HOME2 SUITES FLOWOOD, MS 2nd FLOOR PANELS

- ☒ REVIEWED
☐ REVIEWED AND NOTED
☐ REVISE AND RESUBMIT
☐ REJECTED
☐ RETURNED - SUBMITTAL NOT REQUIRED

Review is in accordance with the provisions of the Project Manual and those listed in the structural notes under "SUBMITTALS".

PANELIZERS, LLC

PNL.#: 2-10d QTY: 3

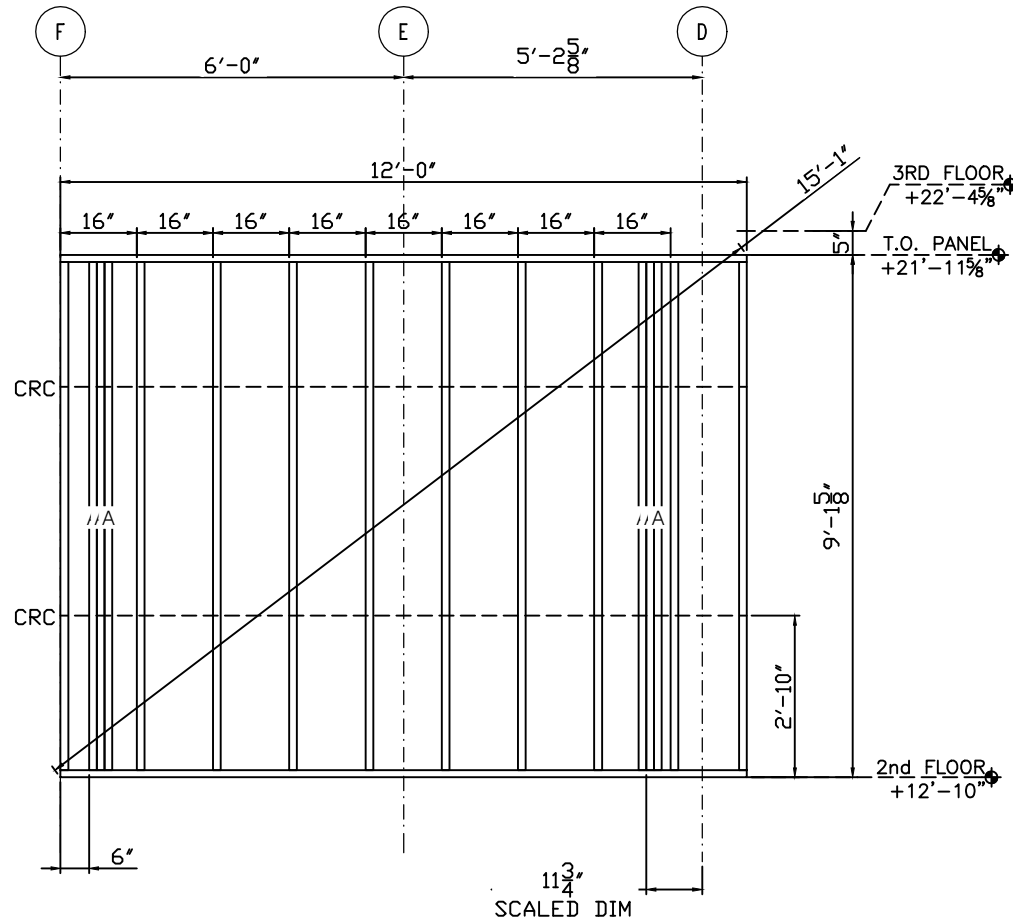
SCALED DIMENSION; SEE W102

PNL.#: 2-11d QTY: 1

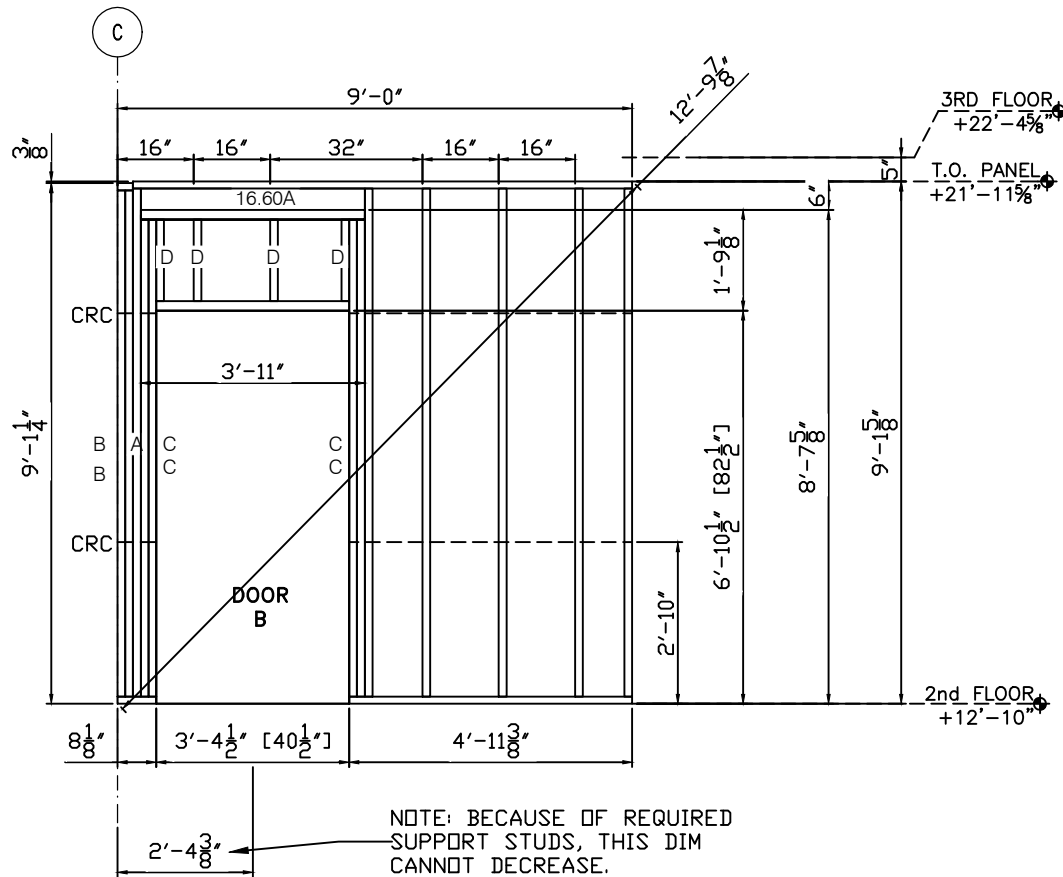
NOTE: BECAUSE OF REQUIRED SUPPORT STUDS, THIS DIM CANNOT DECREASE.

PNL.#: 2-27e QTY: 2

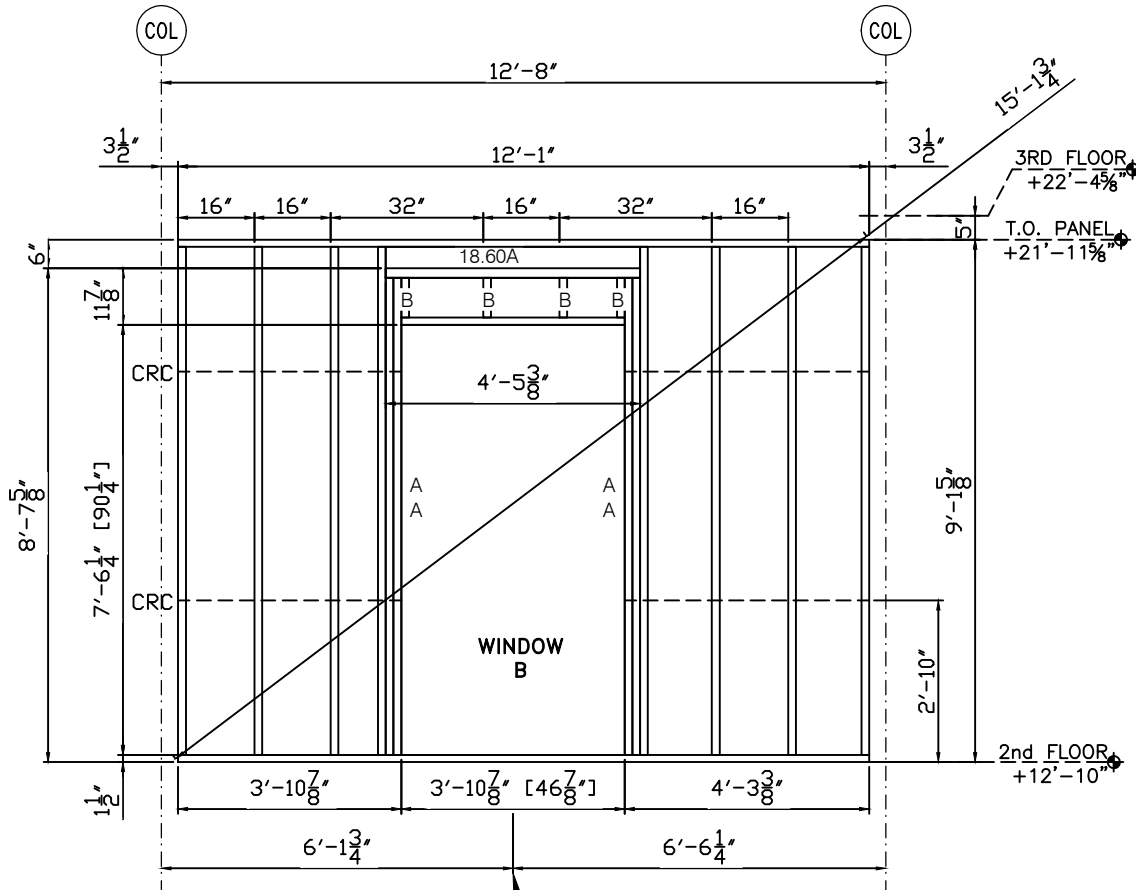
NOTE:
THIS WINDOW NOT CENTERED
TO ALIGN WITH WINDOW BELOW.
SEE 1-51e.

PNL.#: 2-28e QTY: 1

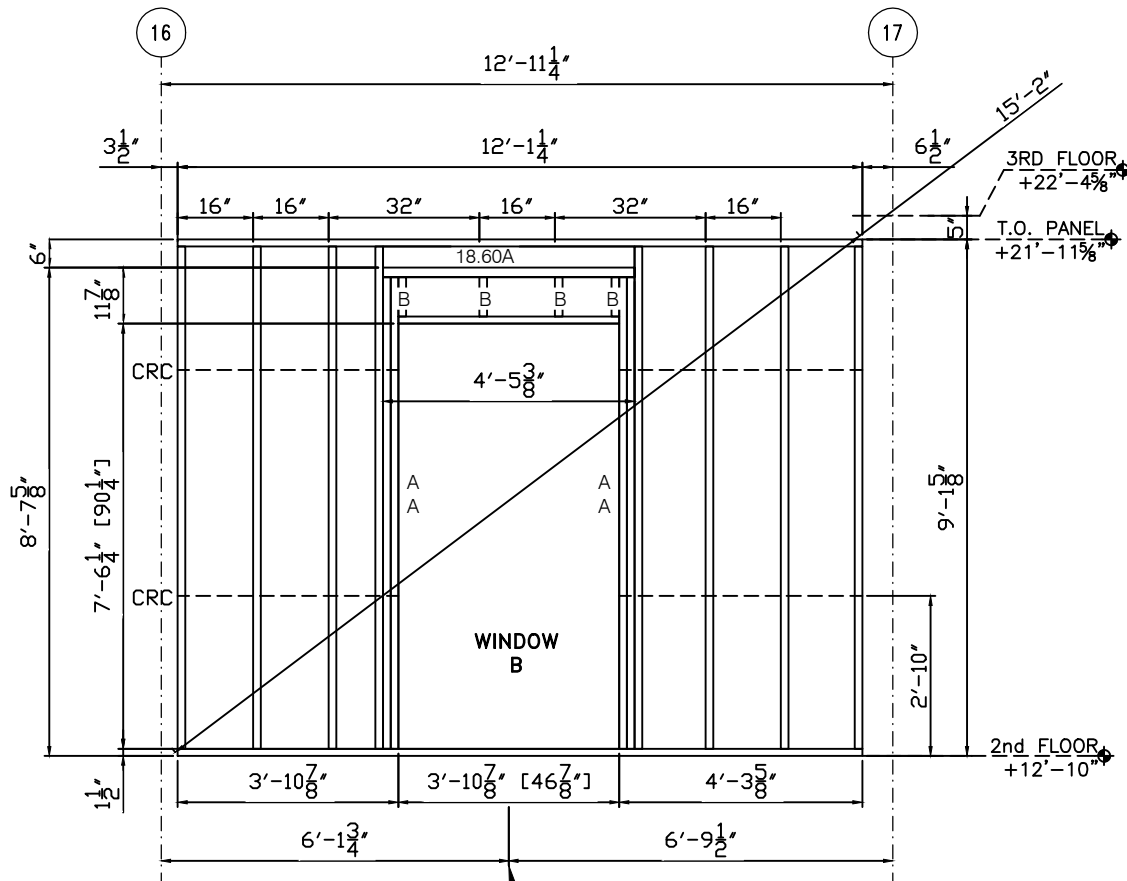
NOTE:
THIS WINDOW NOT CENTERED
TO ALIGN WITH WINDOW BELOW.
SEE 1-51e.

PNL.#: 2-47C QTY: 2

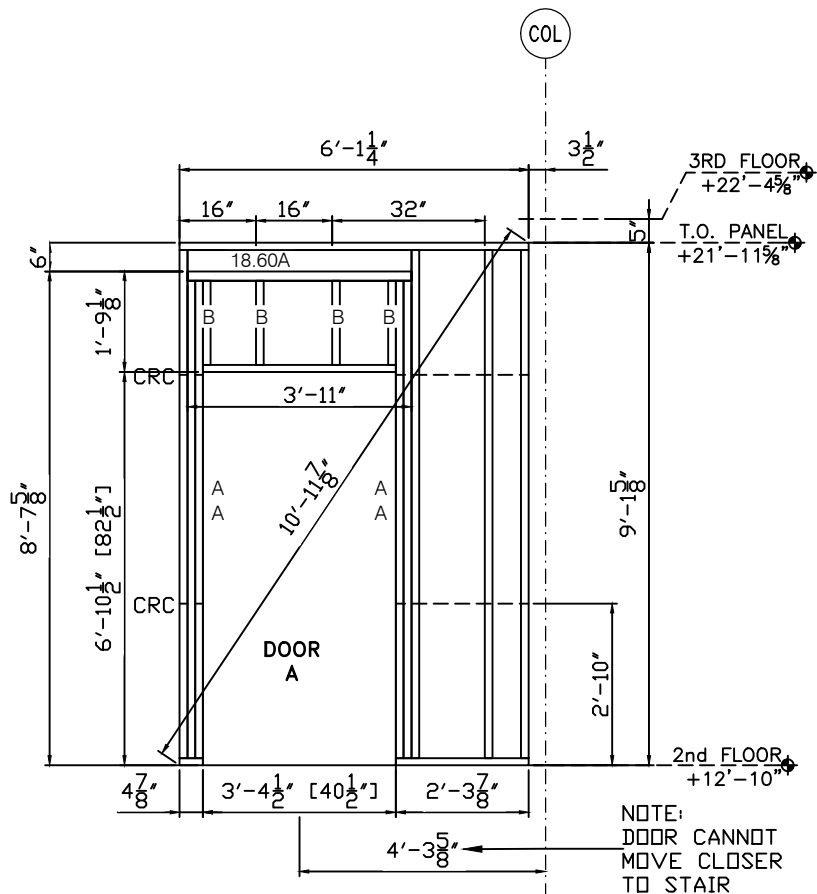
NOTE:
DOOR CANNOT
MOVE CLOSER
TO STAIR
